102440

Belt tensioner

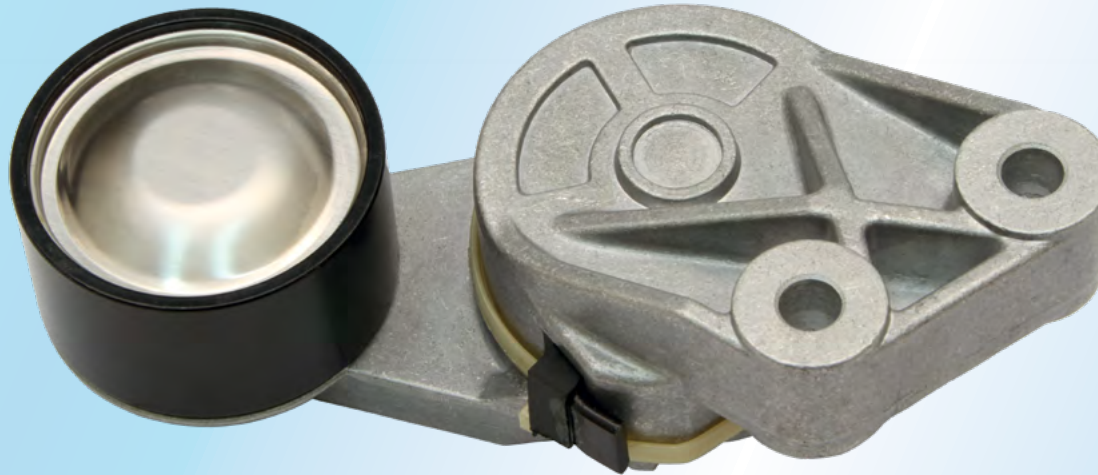
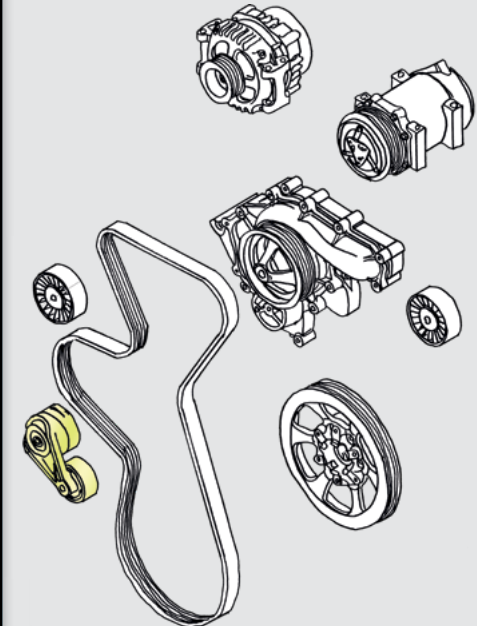
When belt tensioner **Vo ref.** 21422767 is replaced by **Vo ref.** 21454379, bolts needs to be changed.

Belt tensioner **Vo ref.** 21422767 → 2 pcs bolts: **Vo ref.** 21344756 M10 x 55 mm

Belt tensioner **Vo ref.** 21454379 → 2 pcs bolts: Euro 5 → **Vo ref.** 984755 M10 x 40 mm
 Euro 6 → **Vo ref.** 990862 M10 x 45 mm
